48 Shoot-up Hill
London NW2 3QB

Basement Impact Assessment
Audit

For
London Borough of Camden

Project Number: 12336-53
Revision: F1

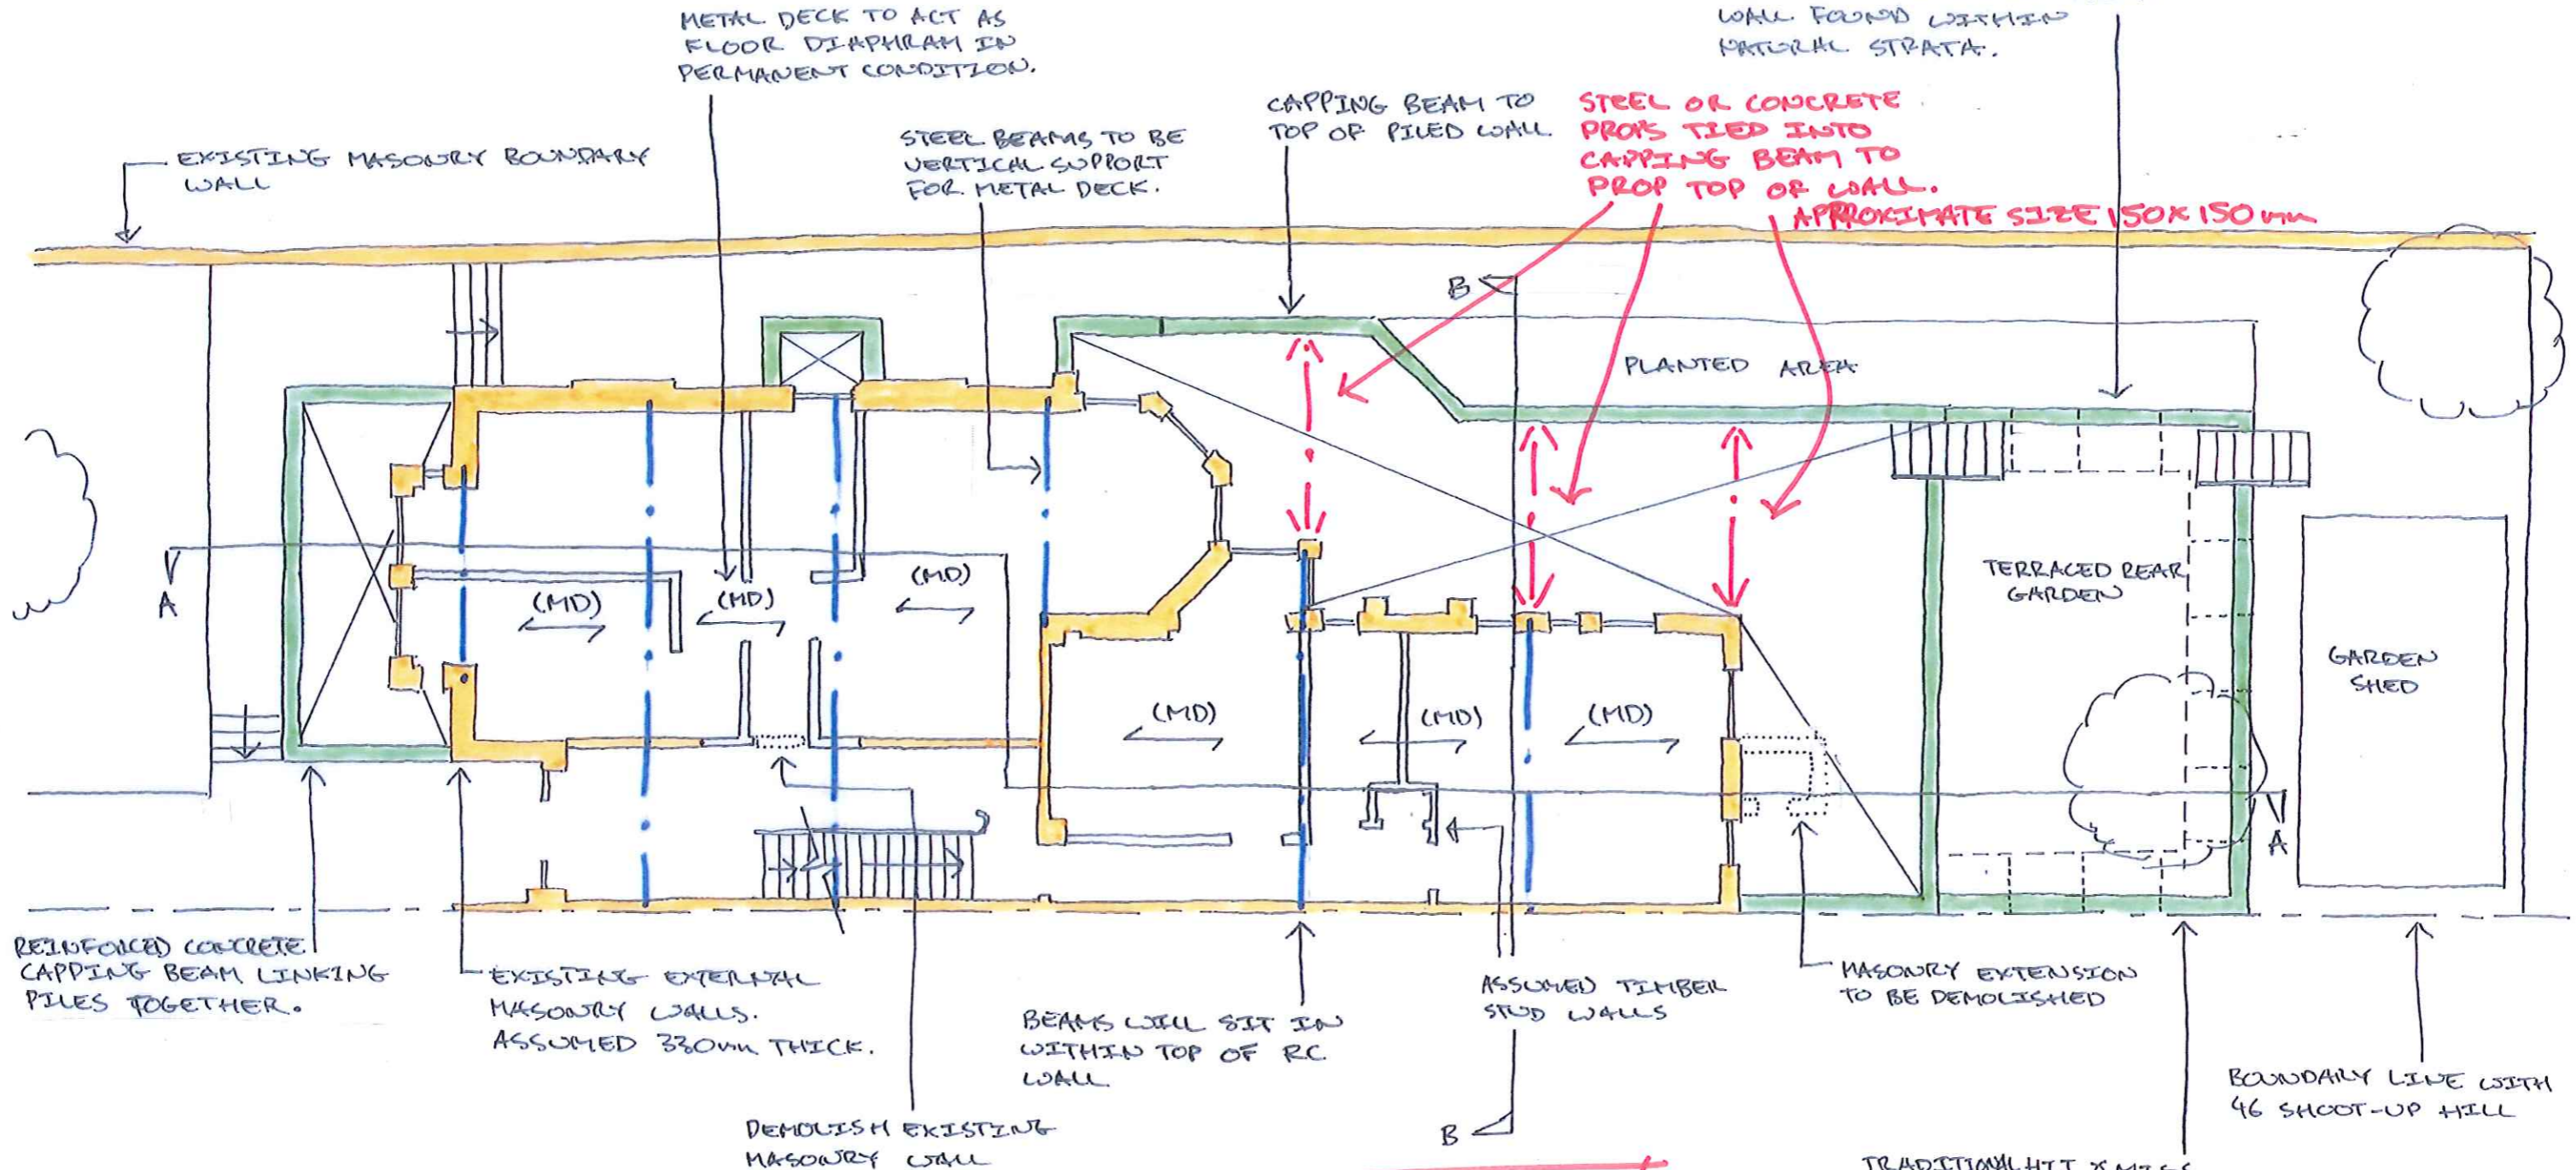
LAYOUT OF NON-STRUCTURAL TIMBER PARTITION WALLS HAS CHANGED. THIS IS TO BE DETERMINED BY ARCHITECT.

CANTILEVERED RC RETAINING WALLS APPROXIMATELY 250mm THICK. TOE LENGTH APPROX 1.5m FROM BACK OF STEM. WALL FOUND WITHIN NATURAL STRATA.

STEEL OR CONCRETE PROPS TIED INTO CAPPING BEAM TO PROP TOP OF WALL. APPROXIMATE SIZE 150x150mm

LOW COMMENTS
30/06/16

TRADITIONAL HIT & MISS SEQUENCE TO BE USED FOR FORMATION OF TERRACED GARDENS RETAINING WALL.
